Docket Nos. 50-269/270/287

The Commission has issued the enclosed Amendment No. 25 to License No. DPR-38; Amendment No. 25 to License No. DPR-47; and Amendment No. 22 to License No. DPR-55 for the Oconee Nuclear Station, Units Nos. 1, 2, and 3. The amendments consist of changes to the Technical Specifications and are in response to your requests dated May 7, 1976.

OCONEE NUCLEAR STATION, UNIT 1

ATTACHMENT TO LICENSE AMENDMENTS

FIGURE 6.1-1

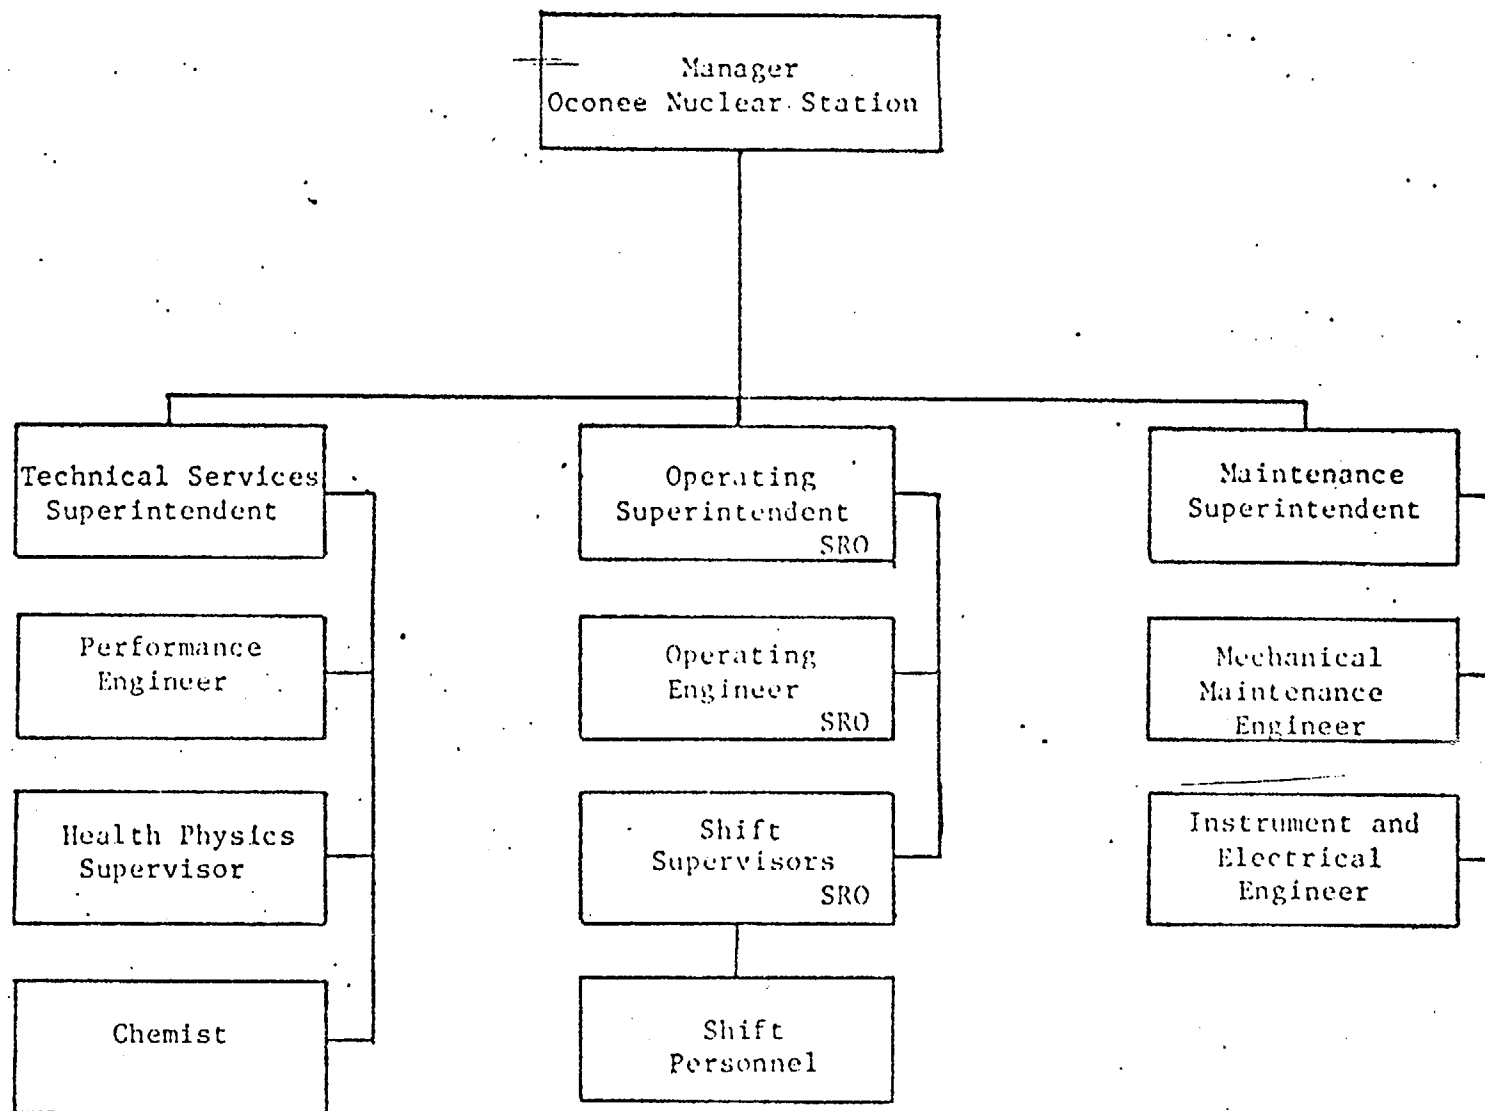
These amendments restructure the Oconee Station Organization for Maintenance by establishing two separate branches for mechanical and electrically-related maintenance. These amendments also revise the provisions in the Technical Specifications to require annual reporting of the nonradiological environmental data.

Remove Figure 6.1-1 (page 6.1-1) and insert revised Figure 6.1-1 (page 6.1-7)
